<b>Delegated Report</b>	<b>Analysis sheet</b>	<b>Expiry Date:</b>	<b>04/08/2023</b>
	N/A	<b>Consultation Expiry Date:</b>	<b>30/07/2023</b>

Obote Hope	2023/2445/P
------------	-------------

100 Hatton Garden London EC1N 8NX	Refer to draft decision notice
-----------------------------------------	--------------------------------

Retention of 2 x air condenser units within the internal courtyard and installation of new acoustic screens at ground floor level.
------------------------------------------------------------------------------------------------------------------------------------

Photo 1 – showing the existing air condenser units location with the nearest residential dwelling.

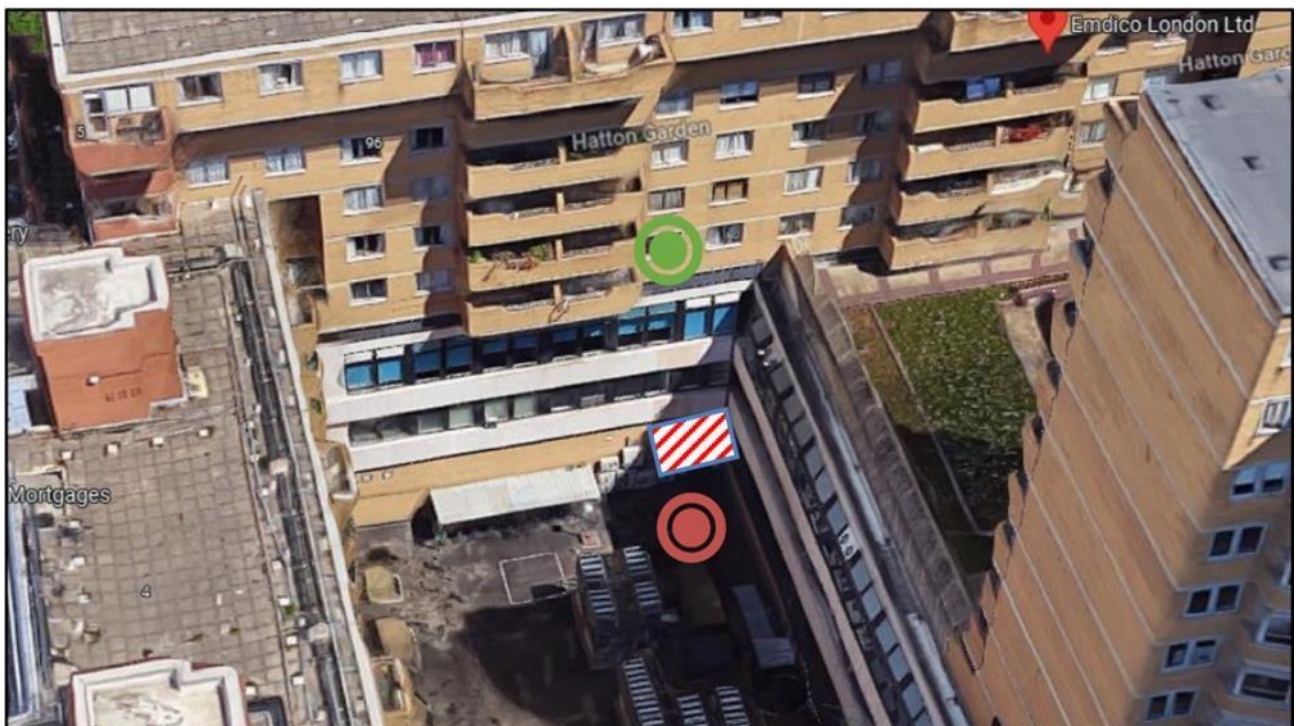
4.3 The nearest residential window is approximately 12m away as shown in the photo below. The existing courtyard would not be visible from the public (as shown on Photo 1 below) the air condenser units remain screened and would not be visible from the flats located to the east of the site.

*Photo 2 – showing the existing air condenser units location.*

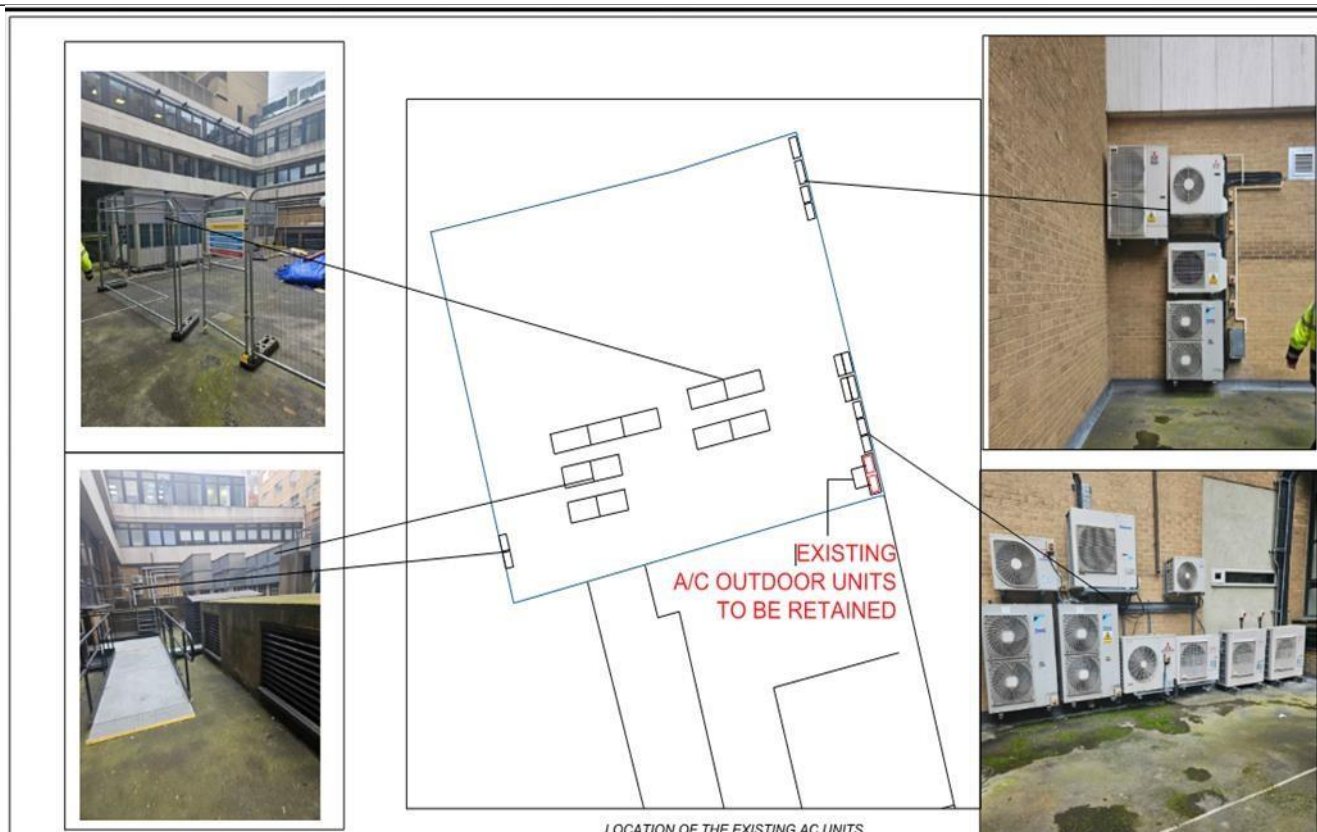
4.4 The air conditioning unit is a typical compact outdoor unit (measuring 700mm high x 900mm wide x 330mm deep) and is mounted on anti-vibration brackets. However, combined with the proposed acoustic screen, both units would measure approximately 2.1m in width and 1.8m in height.

4.5 The existing units would be placed within a proposed enclosure and would be located on the west side of the courtyard facing the host site. As such, would not be visible from rear private gardens or local views. Thus, the proposal would not have any discernible impact upon the character and appearance of the building, wider streetscene and would not be widely noticeable from public views at the front and nor from the residential flats to the rear. As such, the proposed development is acceptable in design terms in general accordance with Camden Local Plan Policy D1 and related Camden Planning Guidance.

*Photo 3 - showing the existing air condenser unit arrangement and the proposed drawing.*

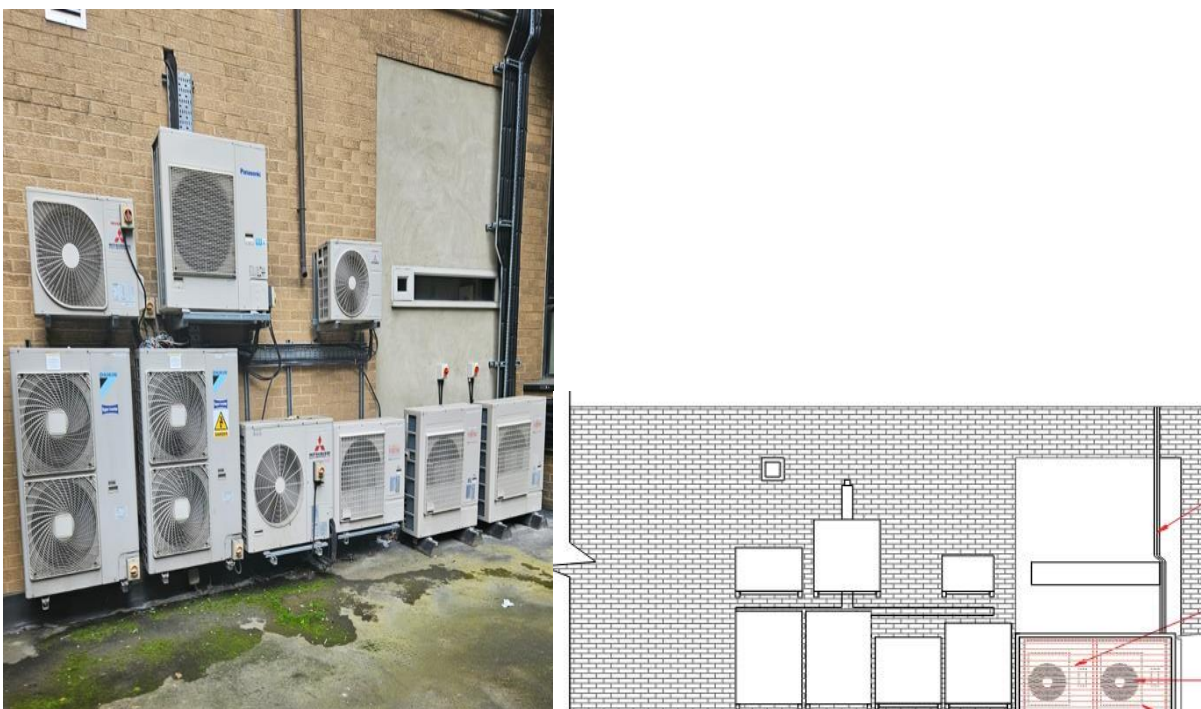
- 6.4 As shown in image 3 below, the drawing submitted with the application indicate that some of the units consist of acoustic enclosure, which further question the accuracy of the submission which is of great concern. Moreover, as indicated by the consultation objection by Gamages Tenants and Residents Association indicate that the existing units are currently contributing to noise nuisance, this is contrary to the submitted Noise impact assessment. The proposal is having a cumulative impact, and this combined with the submitted Noise Impact Assessment which fails to provide evidence that the 30-40 air condenser units forms part of the background noise assessment. Thus, the proposal fails to demonstrate that retaining the 2 x air condenser units would comply with Camden's noise standards such that the amenities of the residential occupiers at the property and the area generally are safeguarded. Thus, the proposal would be contrary to A1 and A4 of the Camden Local Plan 2017.

6.5 Overall, the proposal is having a cumulative adverse impact on the amenity of residential occupiers in terms of noise and vibration. As such, the proposal is contrary to Camden Local Plan Policies A1 and A4, and related Camden Planning Guidance in this regard.
